ACCESSION NBR: 7905240475 DOC. DATE: 79/05/21 NOTARIZED: YES DOCKET #
 FACIL: 50-269 OCONEE NUCLEAR STATION, UNIT 1, DUKE POWER CO. 05000269
 50-270 OCONEE NUCLEAR STATION, UNIT 2, DUKE POWER CO. 05000270
 50-287 OCONEE NUCLEAR STATION, UNIT 3, DUKE POWER CO. 05000287

SUBJECT: FORWARDS PROPOSED AMEND TO DL TECH SEPCS CHANGING SETPOINTS OF PRESSURIZER ELECTROMAGNETIC RELIEF VALVE & REACTOR COOLANT SYS HIGH PRESSURE TRIP IN RESPONSE TO IE BULLETIN 79-05B.

Re: Oconee Nuclear Station
Docket Nos. 50-269, -270, -287

OCONEE NUCLEAR STATION
PROPOSED TECHNICAL SPECIFICATION REVISION

Figure 2.3-1A

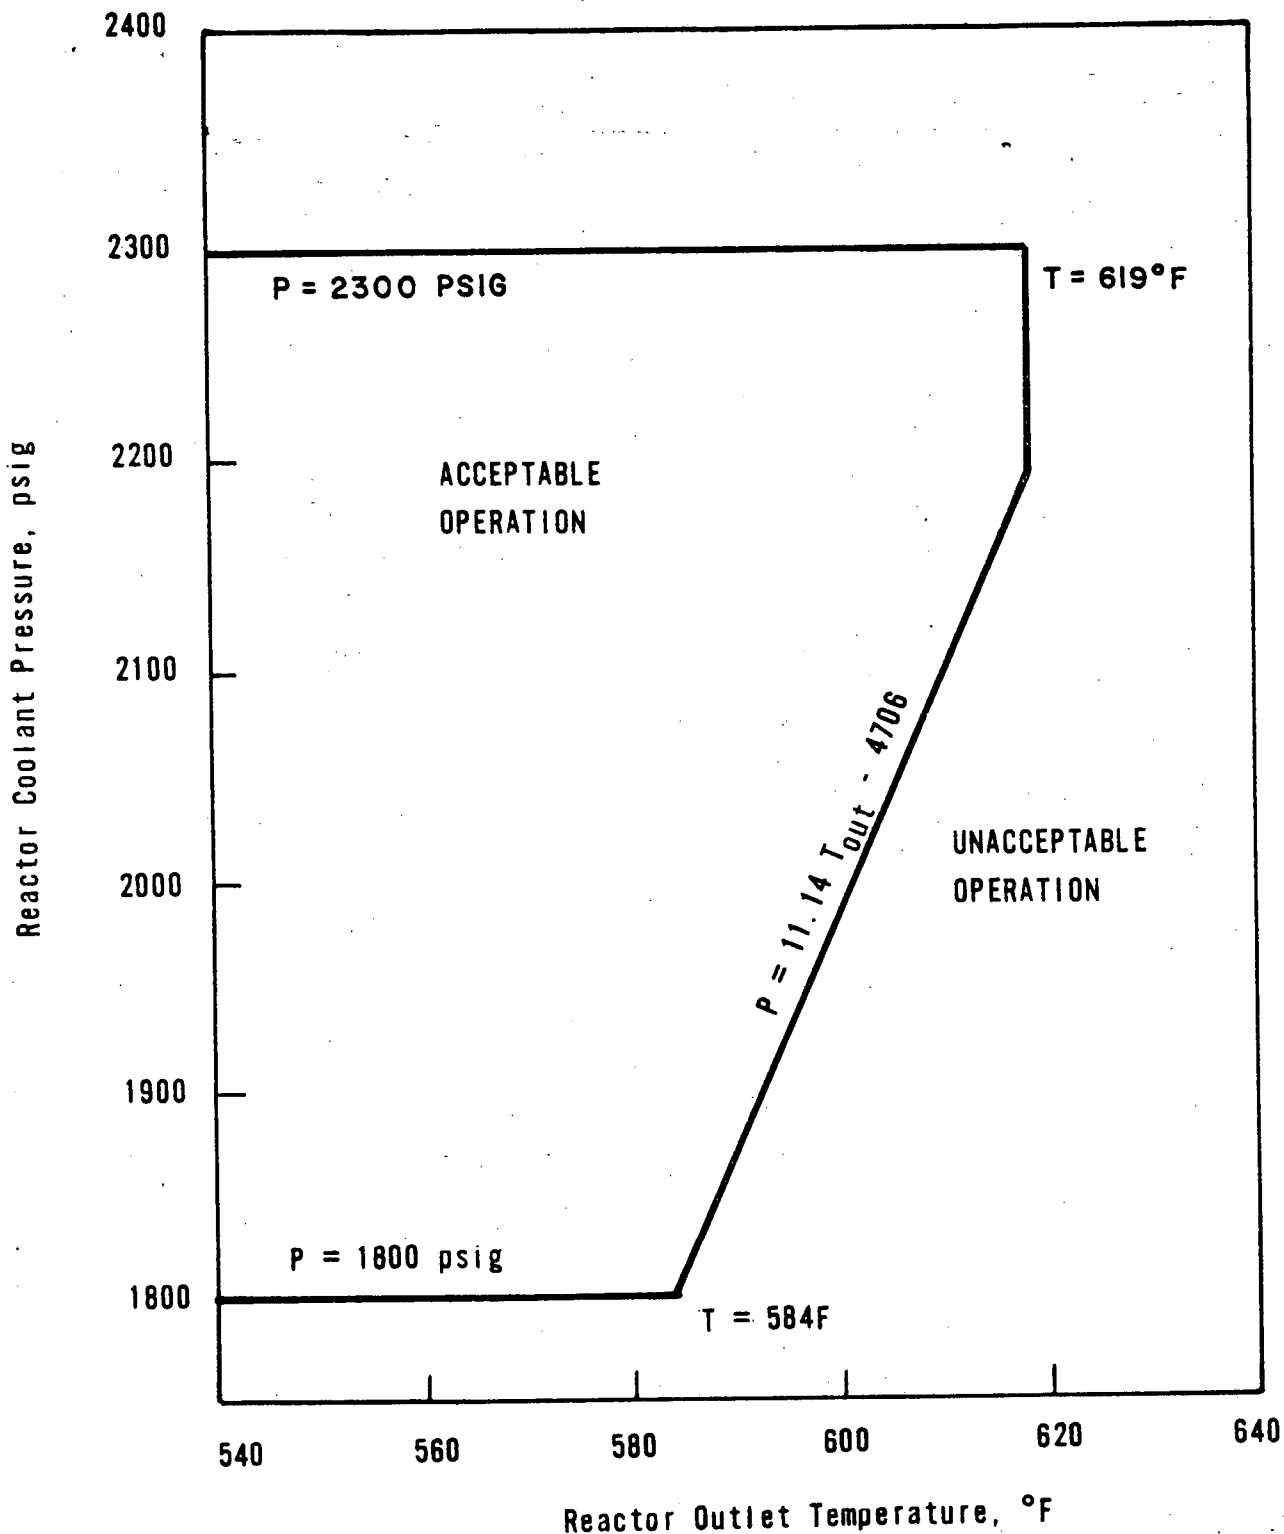
This proposed revision reflects recent changes to the setpoints of the pressurizer electromatic relief valve and the reactor coolant system high pressure trip made in response to IE Bulletin 79-05B.

During a startup accident from low power or a slow rod withdrawal from high power, the system high pressure set point is reached before the nuclear over-power trip set point. The trip setting limit shown in Figure 2.3-1A - Unit 1

for high reactor coolant system pressure (2300 psig) has been established to maintain the system pressure below the safety limit (2750 psig) for any design transient. (1)

Figure 2.3-1B

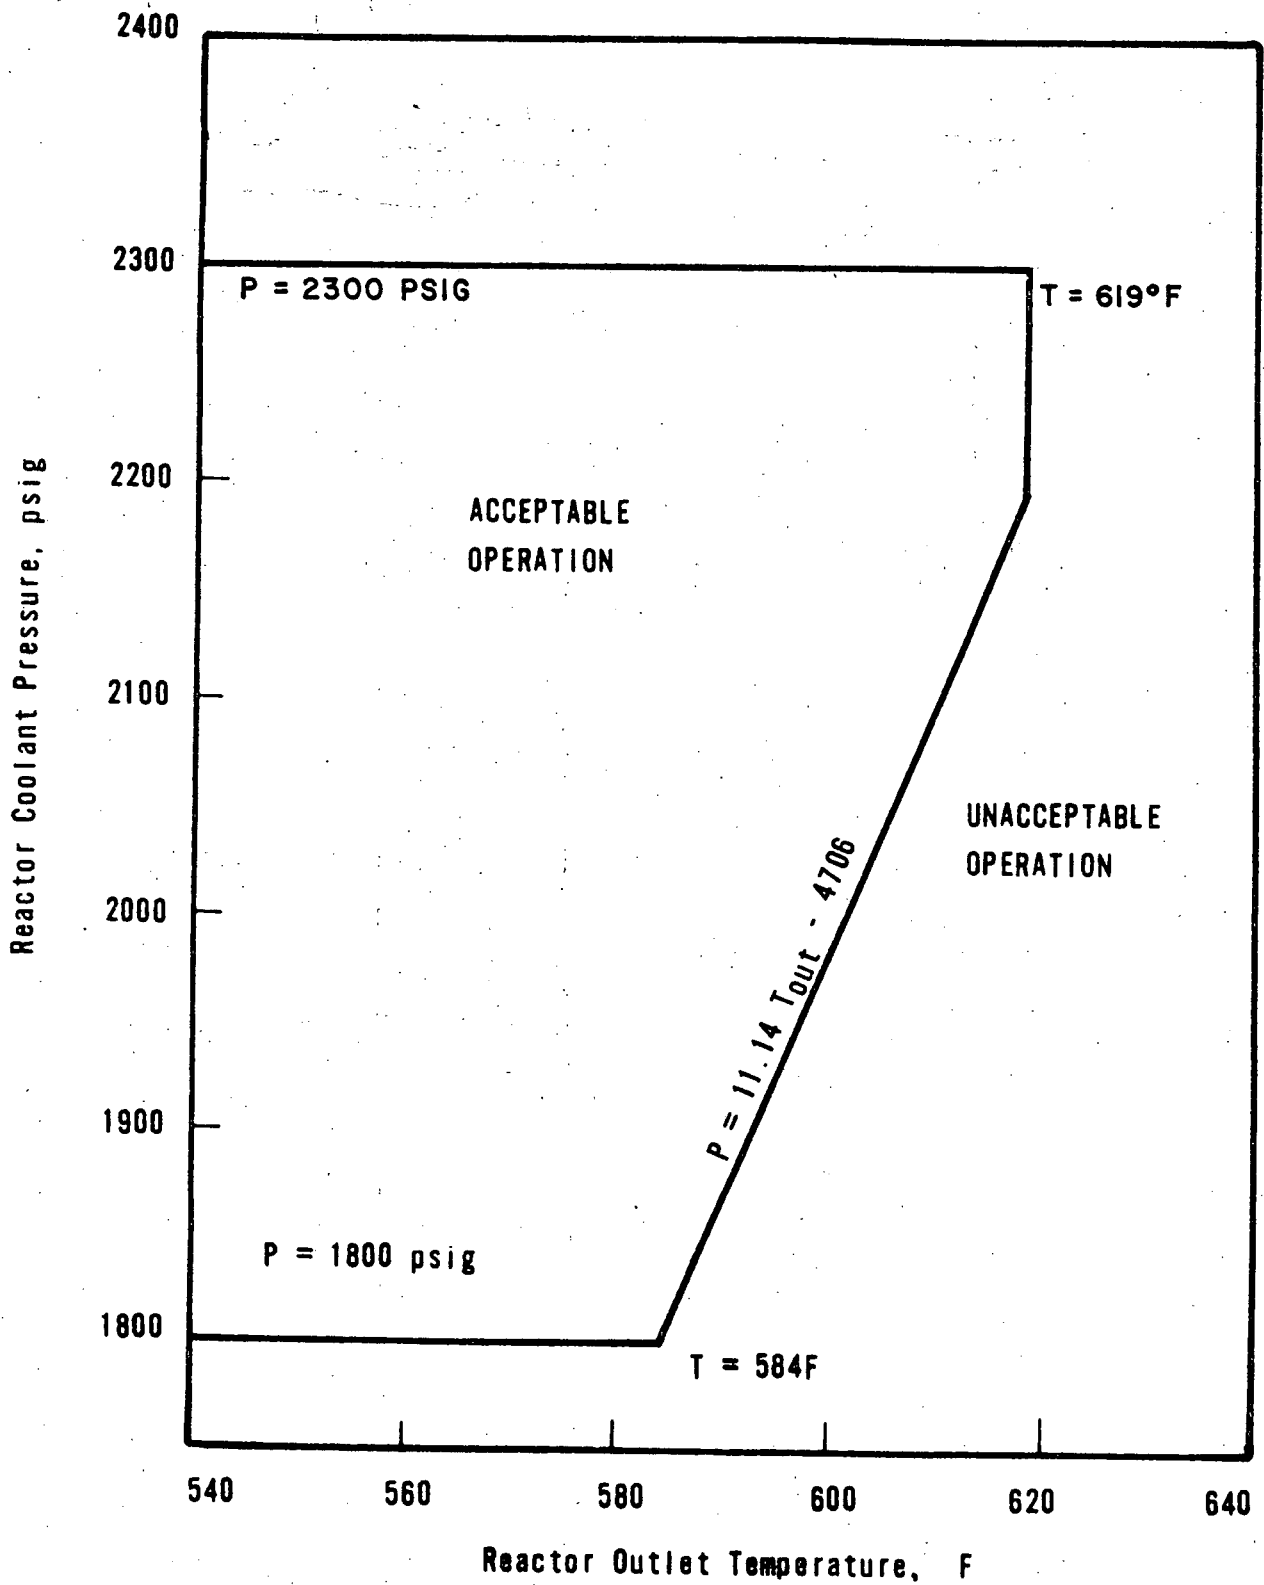
2.3-1B - Unit 2
